TECHNICAL SERVICE BULLETIN 980530-007

TITLE:
FRONT WHEEL DRIVE GEARBOX

APPLICABLE MACHINES:
530E

DRIVE GEARBOX

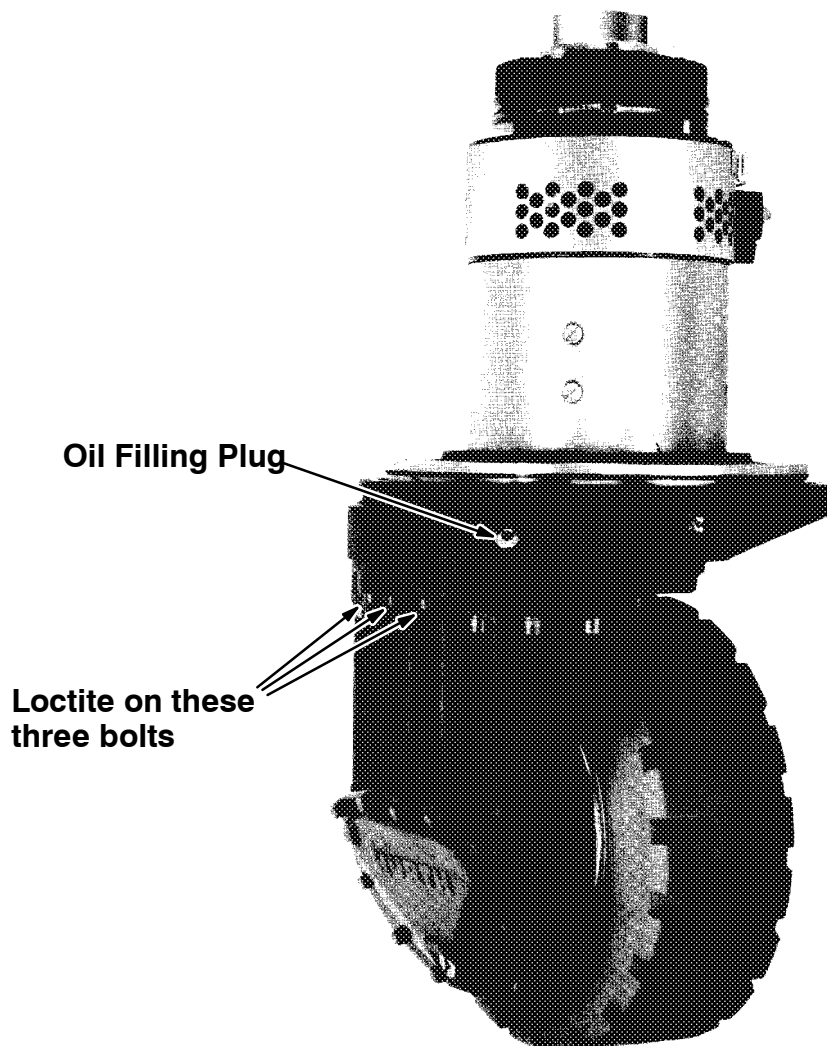
The front wheel drive gearbox might leak after only a few hours of operation.

To stop the leaking, first check the fluid level and drain any excess fluid. Then remove the 3 bolts located below the oil filling hole. Clean and apply Loctite #515 or #242 and torque to 17 ft lbs. Use 90 wt gear lube, capacity is 2.7 liters.
